## Product Change Notification

Product Change #: 291 affecting 'Elbow Tube Fittings' L420-410, L230-220, L220-210 and L230-210 in all materials and the Kits that these go into namely, the Tube-to-tube, Complimentary, Assorted and Sample kits

Posting Date: **Feb. 18, 2015**

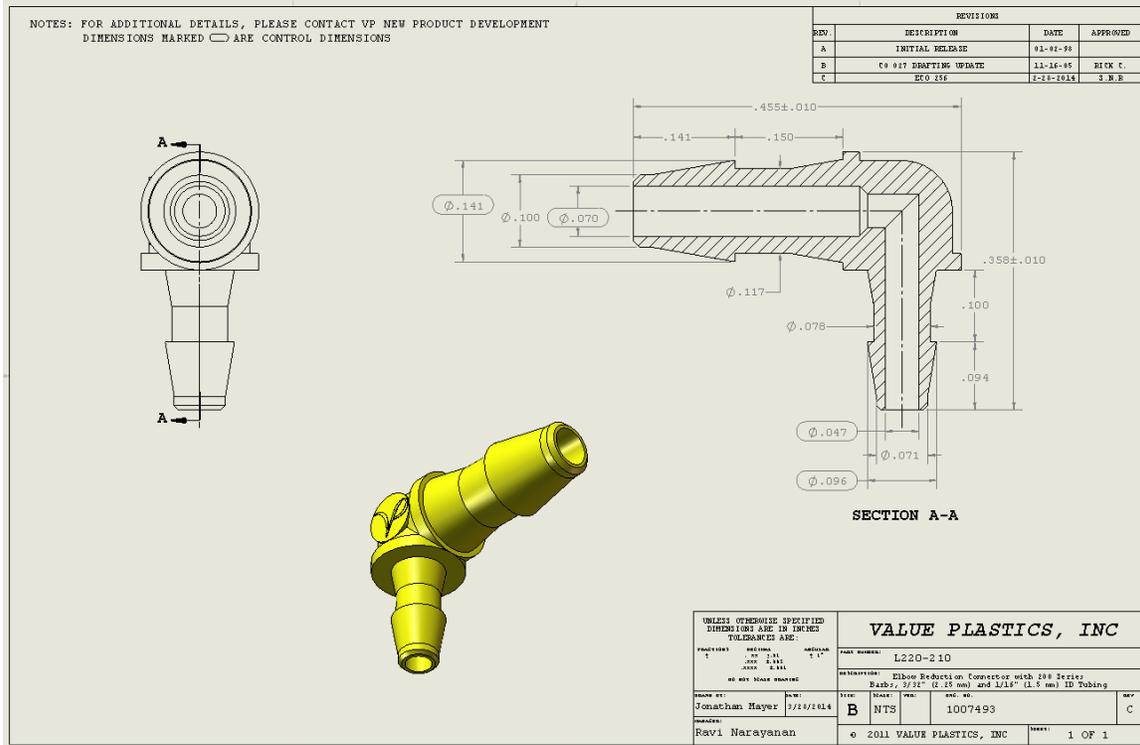
Description of Change: The middle section (grip) of these elbow tube fittings will be modified to have a flat. Additionally the inner diameter (ID)'s have been provided with a 0.5 degree draft.

There will be no change to part numbers or materials. A representative image of the change with respect to the flat grip is shown as below.
